From: Sandin Phillipson <sedphil24@comcast.net>
Sent: Thursday, August 15, 2019 1:44 PM
To: Tom Connelly
Cc: Wendy Scatterday
Subject: GC&P Development-Planning Commission Invited Comments
Attachments: Planning Commission Cover Letter.doc; Slope Stability of the Ridge.doc; Mine Subsidence.doc

After attending the August 12, 2019, meeting of the Planning Commission and reviewing the available material relevant to the proposal from GC&P Development, LLC (Applicant) regarding revision to Wheeling's Comprehensive Plan and consideration of zone change to facilitate their construction of a mixed use village adjacent to Woodsdale, I, as a resident of Woodsdale, have several concerns that I believe should be considered by the Commission. Given the state of the Applicant's submittal, I believe the current Comprehensive Plan designation for Parcel W26-90, W26-90.2, and W32-99.2 is appropriate and should not be changed. The Applicant's submittal package fails to address several important considerations, as described below.

Slope Stability of the Ridge
Bounded by
Woodsdale, Waddles Run, and SR88

Previous Mining and Mine Subsidence Potential

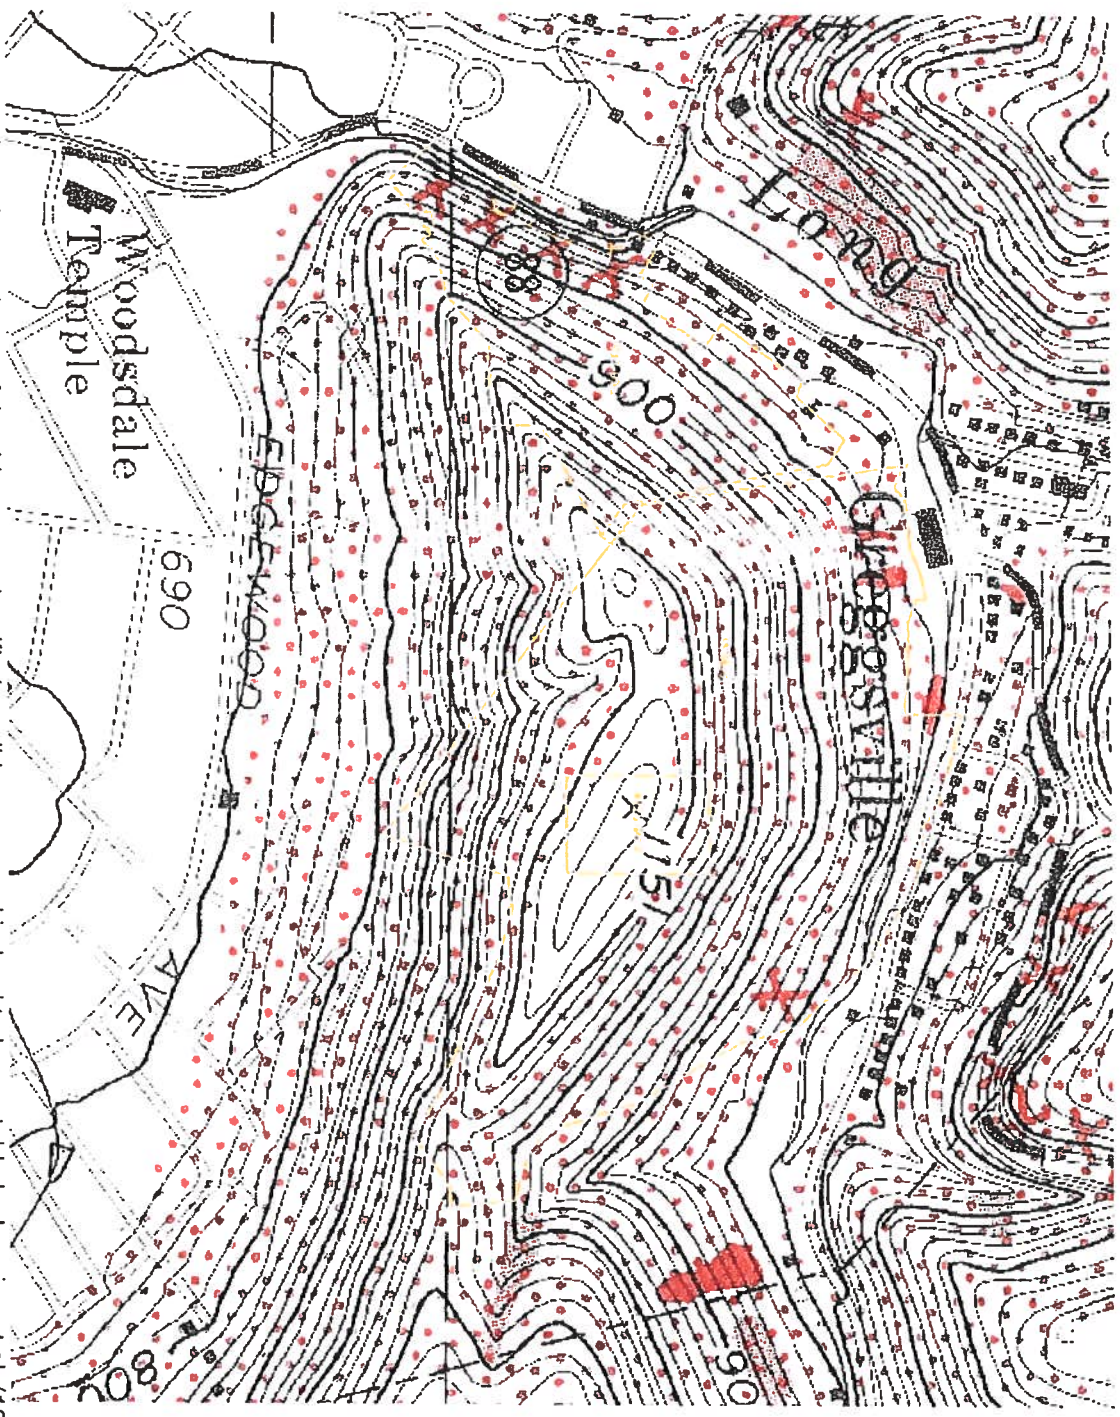
The southern and western slopes are perhaps the most critical because approximately three-dozen homes lie along the base of the ridge, with the rest of the neighborhood of Woodsdale spread out in the valley below to the south in close proximity. The "angle of repose" of sand, gravel, and wet earth, representing a proxy for natural materials already found on the hillsides, is 20-30°. That is, these natural earth materials cannot be piled higher than at an angle of 20-30° before they flow under the force of gravity to define a stable pile with a lower aspect ratio. The ridge bounded by the Woodsdale neighborhood and Waddles Run can therefore already be considered as meta-stable, as it is characterized by slopes of 24-30°. That is, the slopes would exhibit a tendency toward failure except that abundant vegetation binds unconsolidated material together, and intervening layers of sandstone shelter weaker layers of shale from advanced erosion. Although intermittent layers of sandstone are strong enough to strengthen the overall ridge, the slopes themselves are subject to constant mechanical erosion as unconsolidated material is pulled down slope under the force of gravity. This process is evidenced by areas of creep and old earthflows at the base of the ridge, where large volumes of clay-rich soil derived from the weathering of shale were allowed to collect after historical clear-cutting allowed uncontrolled surface erosion.

Figure 4. Landslides (red stipple) are shown from remote observations along with the parcel boundaries. Extensive tree removal has been performed since this aerial photo was taken in 2009.

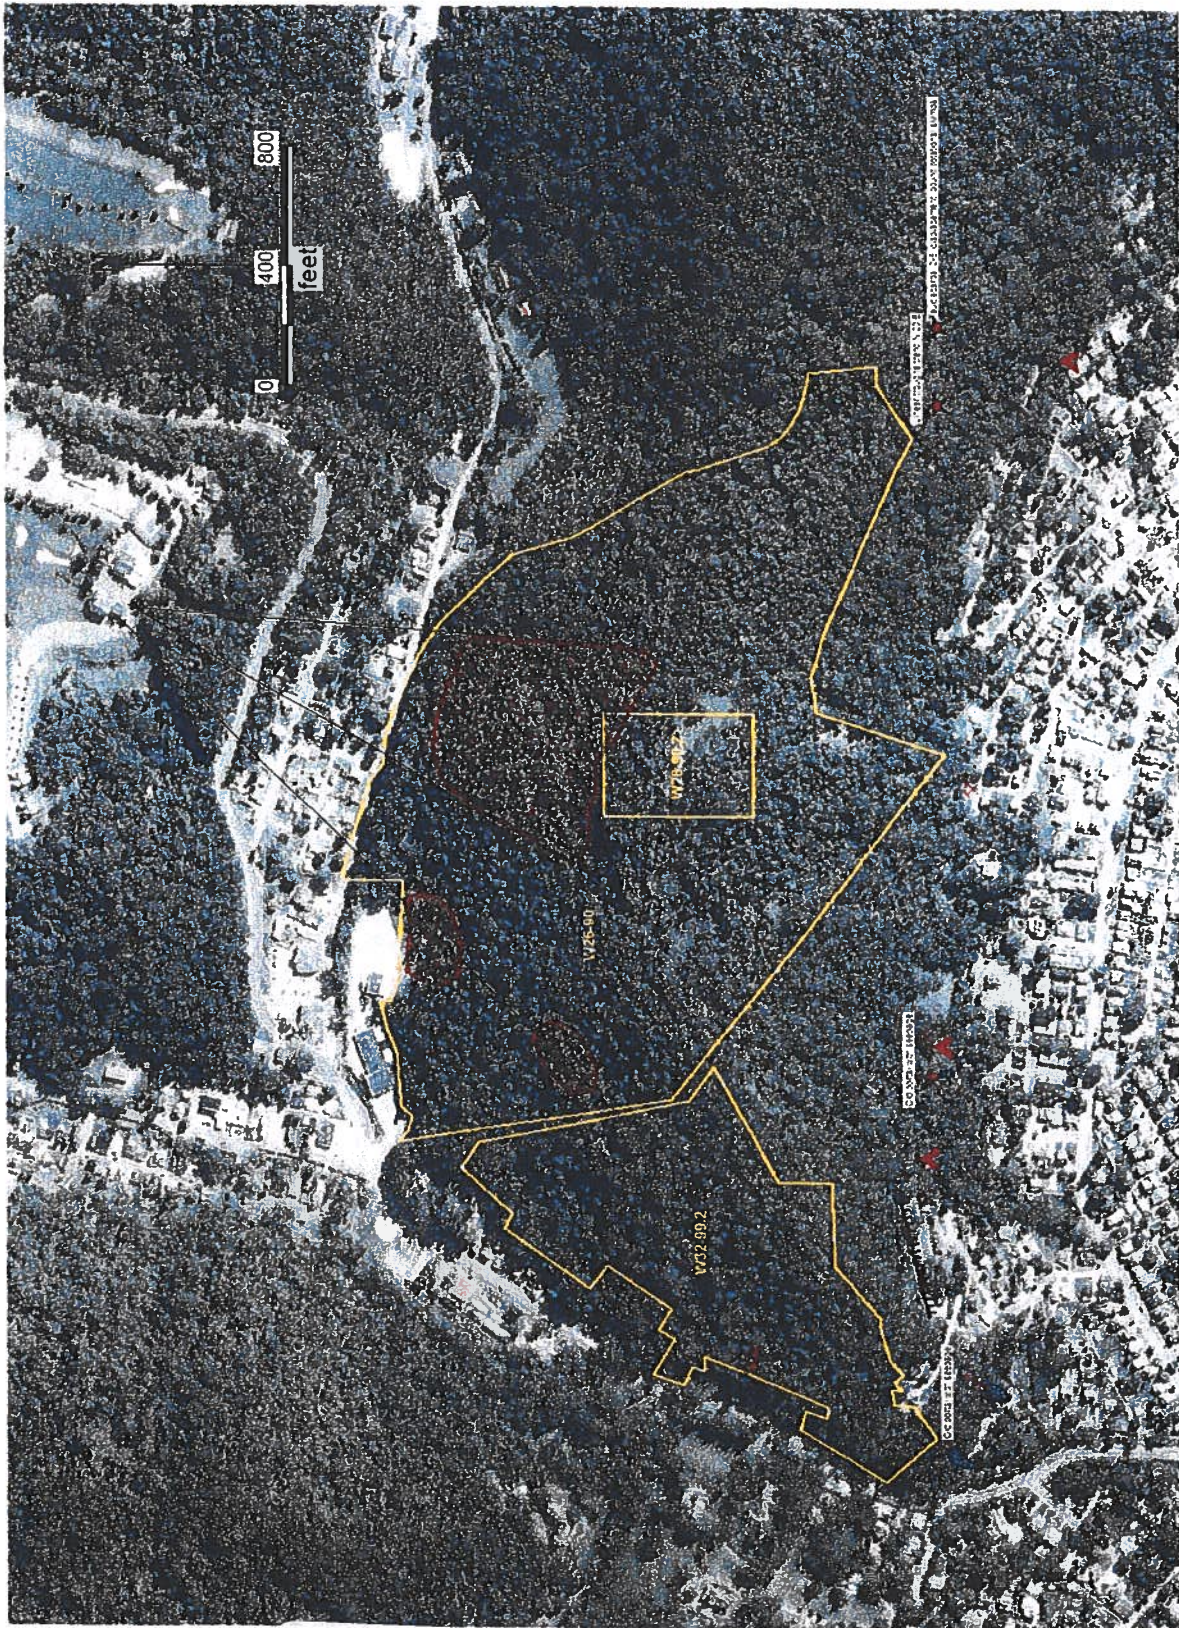
Although the northern and western slopes could not be directly accessed because of respect for private property, they can be viewed from ridge tops on the opposite side of Waddles Run to gain a broad, panoramic perspective. Several large failures, which appear to represent earthflows, are present on the north slope of the ridge, and may have occurred after rains associated with Hurricane Ivan in 2004 (Figure 4). The largest such earthflow is estimated as 800 feet in width, extending for virtually the entire height of the slope (Figure 5). The earthflow truncated the former access road to the top of the ridge, and also truncated at least 5 former logging roads arrayed along horizontal terraces on the side of the ridge (Figure 6). It should be noted that in the summer of 2014, the truncated former logging road was re-established by earthmoving equipment, thereby undercutting the toe of the large earthflow. Because of extensive tree removal conducted on the northern slope during the summer of 2013, the approximate top 60 feet of elevation has been virtually denuded, and the toe of a small earthflow appears to have truncated the highest former terrace (Figure 7). Figure 8 represents what appears to be a debris flow, composed of jumbled rock and mud on the slope above the current C-3 Church in an area of extensive tree removal. This feature may, however, represent bulldozer activity from 2013.

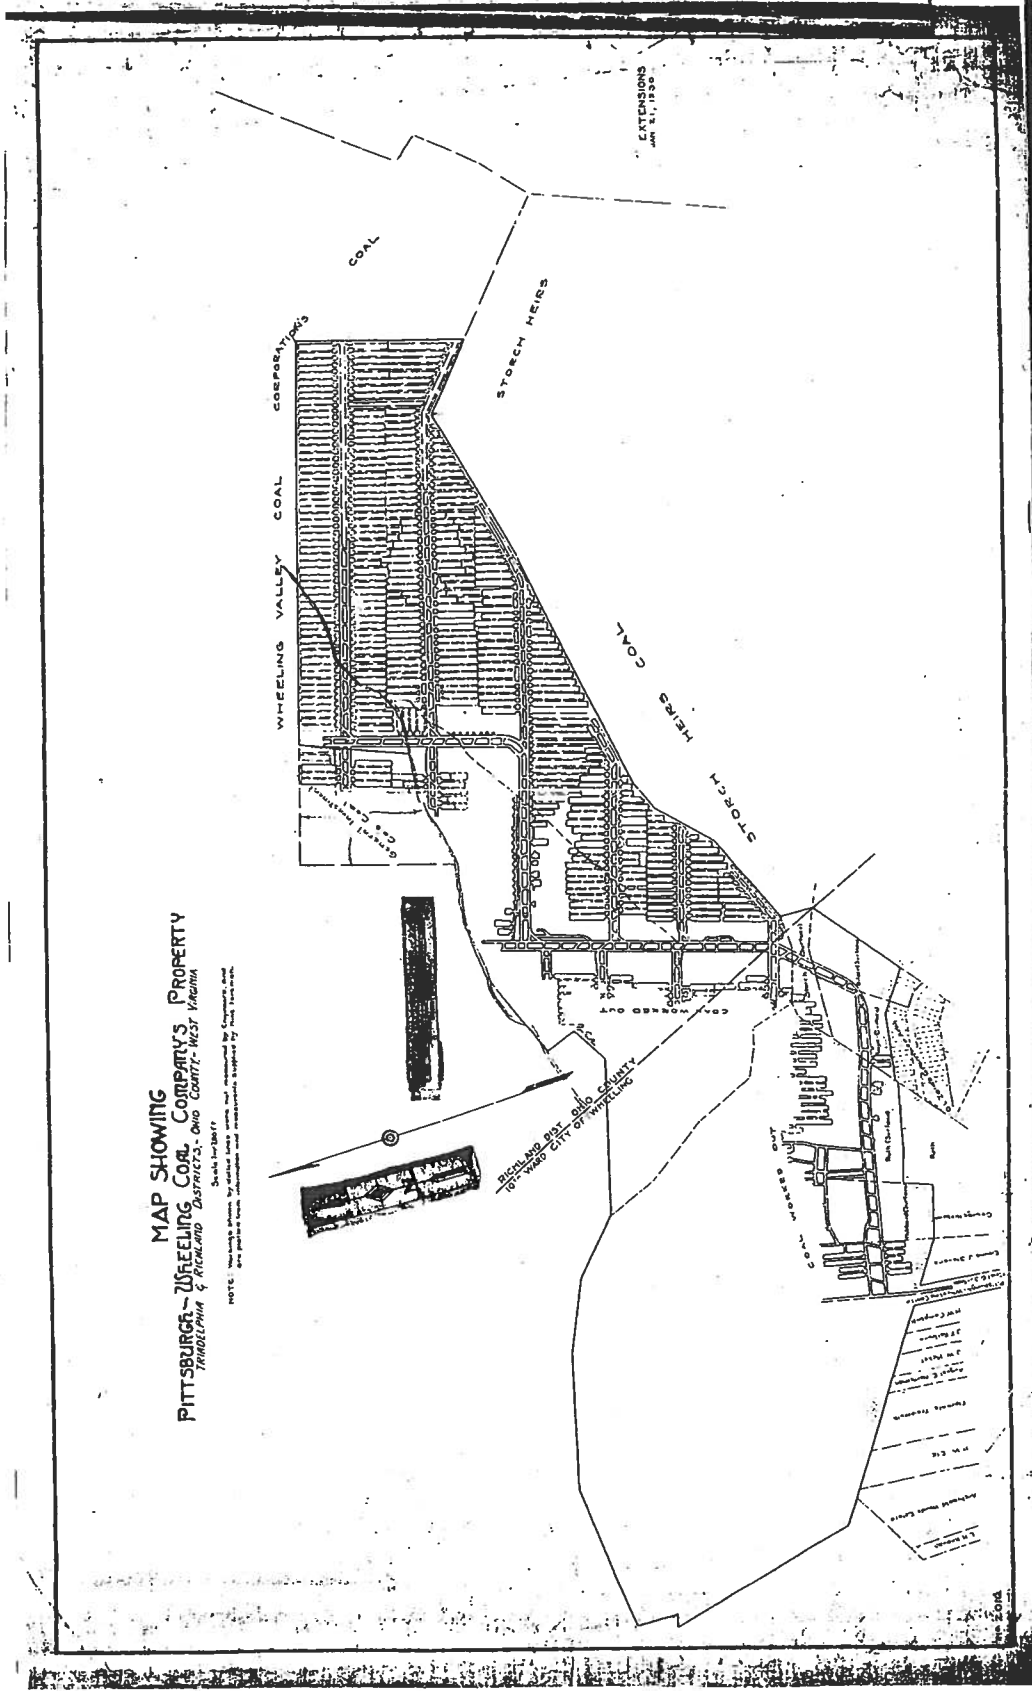
The map of the Pittsburgh-Wheeling Coal Co.'s Edgewood Mine (portal located at - 80.68440° E/40.08334° N) obtained from the West Virginia Geologic and Economic Survey indicates that the entirety of the ridge between Greggsville and Woodsdale was "worked out" with no indication of the sizes of any pillars or barriers that may have been left intact to support the weight of the ridge (Figure 4). However, the mine map provides an indication of the mining pattern in workings portrayed to the east, which are likely to have been similar to those in the western half of the mine. In this pattern of mining, the Pittsburgh Seam was accessed by a 2-entry submain used for track haulage. The two track entries are separated by a string of solid coal pillars measuring 65 feet long by 25 feet wide, each separated by a crosscut. Flanking the track entries to the left and right, 250-foot wide panels of essentially unlimited length were driven to the property boundaries. The panels are characterized by long, slender pillars of coal, also referred to as "fenders," that are all that remained of extracting coal from each "room." Each 130-foot long "room" is up to 25 feet wide, separated from the next room by a thin pillar 10 feet in width. The mouth of each room is flanked by a small coal pillar that was left in place to protect the track entries from stress. Together with the large pillar separating the two track entries, the two flanking pillars constitute what is known as a "composite barrier." This composite barrier system is expected to have very high stability, and was intended to resist crushing out in order to protect the track entries from the weight of overlying rock, thereby allowing continued mine access even if the flanking worked-out panels experienced collapse.

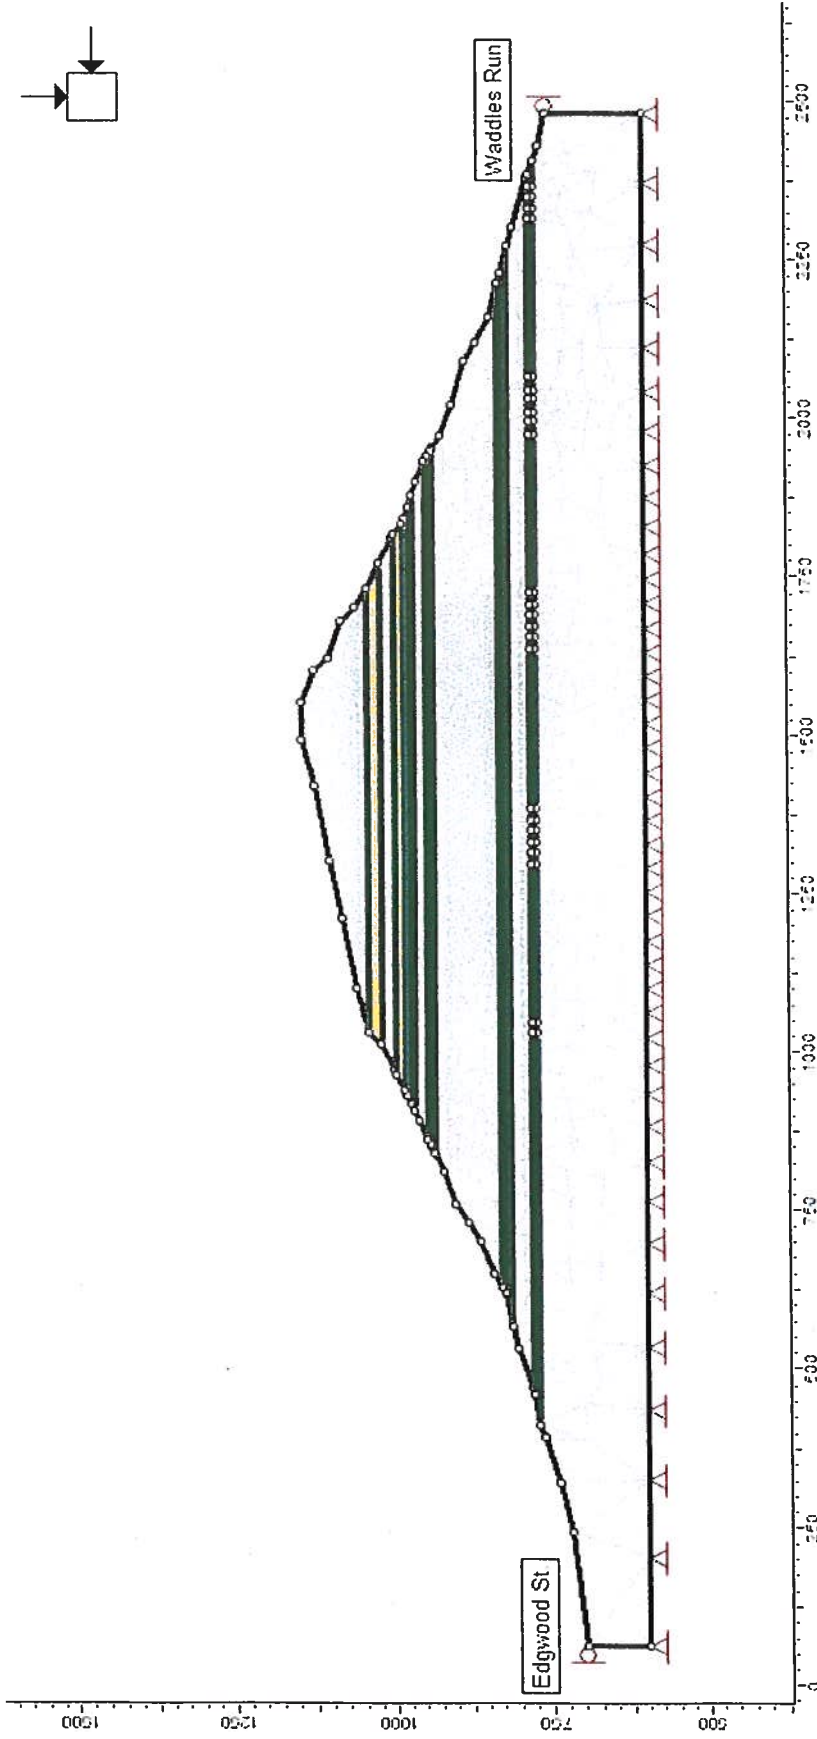
To better understand the relation between the surface topography of the ridge bounded by Woodsdale and Waddles Run, and the underlying mine workings, a copy of the map of the Pittsburgh-Wheeling Coal Co.'s Edgewood Mine obtained from the West Virginia Geologic and Economic Survey was geo-referenced in a Geographic Information System and superimposed on a Digital Raster Graphic of the U.S. Geological Survey's Wheeling 7 ½' topographic quadrangle (Figure 5). As a check on the accuracy of the geo-referencing, the map was displayed with the digitized boundaries of coal mines obtained from the West Virginia Geologic and Economic Survey's Interactive Coalbed Mapping Project.

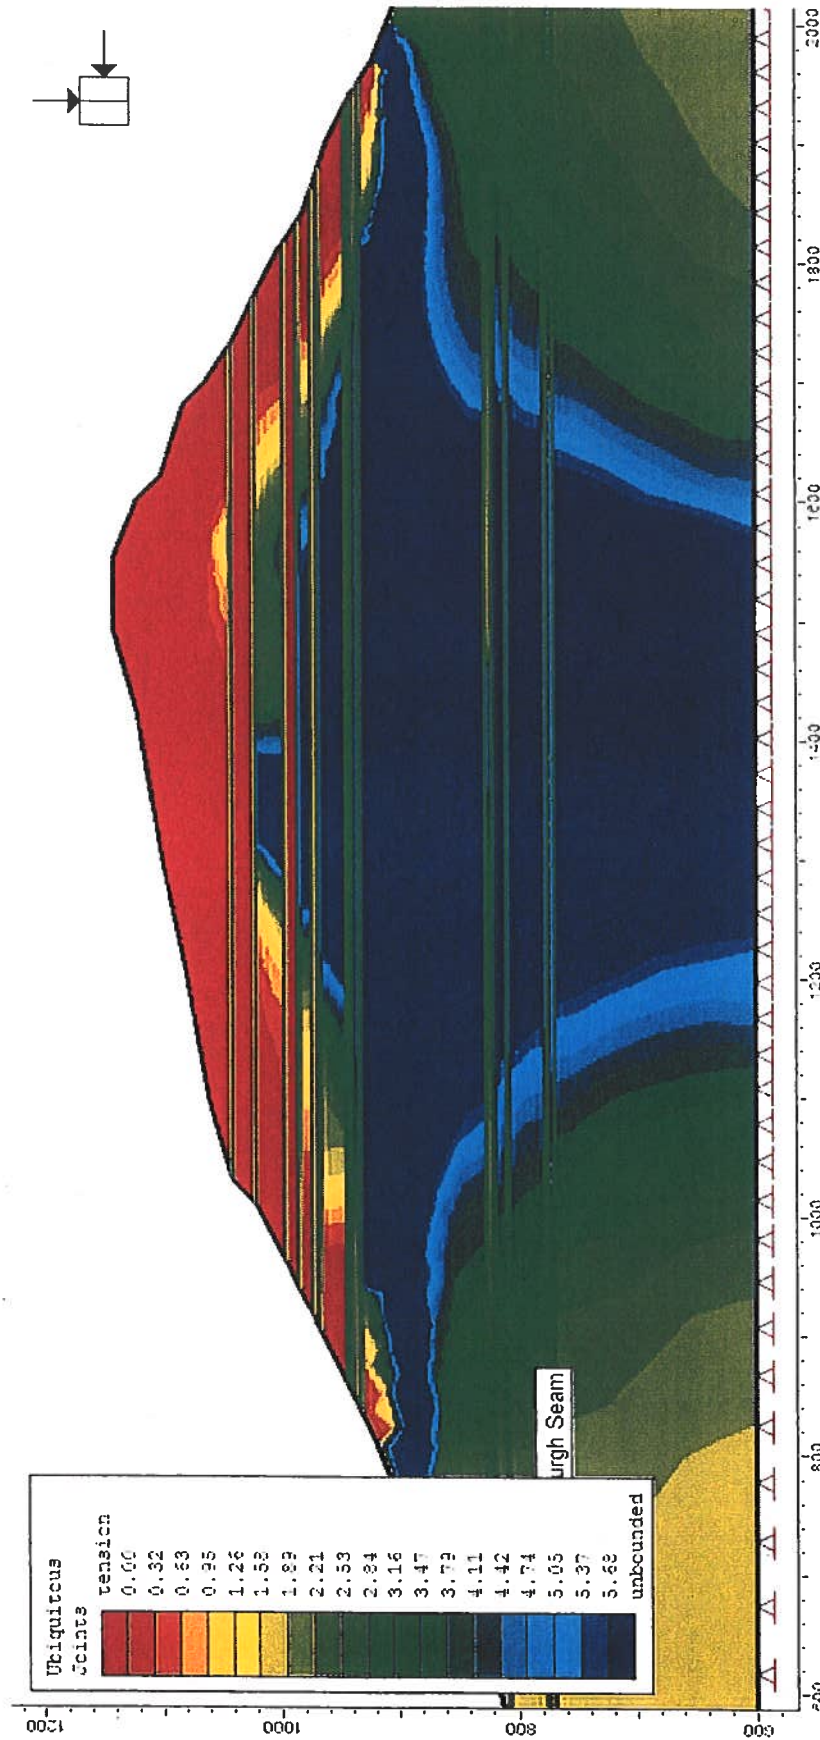
the coal fenders in the production panels indicate that failure is very likely. Complete extraction was therefore assumed for purposes of modeling. If the thin fenders have not already failed, then collapse would now be dramatic. Figure 9 represents the distribution of "Strength Factors" in the calculated mesh displacements for the pre-mining situation shown in Figure 6. At this stage, no coal has yet been extracted, and the model predicts only surface slope movement under the force of gravity at the unconstrained surface of the earth. The models incorporate a feature known as "ubiquitous joints," meaning that joints are assumed to exist everywhere in the rock mass. Based on observations of strata on the ridge, the incorporation of ubiquitous joints is justified because vertical joints were measured in sandstone members. The presence of vertical joints is significant because they dismember the continuity of the strata and reduce or eliminate bridging capability. Figure 10 represents the distribution of Strength Factors for the mining situation shown in Figure 7 in which excavation of the 2-entry track haulageways has been completed. The excavation of these narrow tunnels has virtually no effect on the overlying rock mass because the strata, even when cut by joints, are expected to easily span the narrow openings. Figure 11 represents the distribution of Strength Factors after extraction of coal from the production panels flanking the 2-entry track haulageways. With no stable coal pillars to support the weight of the ridge, joint-bounded blocks are predicted to fail above the 250-foot wide mine voids, with zones of failure reaching the surface. Figure 12 further demonstrates the tendency toward subsidence with the pattern of stress vectors, which all point downward into the voids created by coal extraction in the panels. Finally, Figure 13 supports the interpretation of failure that was indicated by the distribution of low Strength Factors and stress vectors, predicting negative or downward displacement, in other words subsidence, of the top of the ridge above the mine voids.
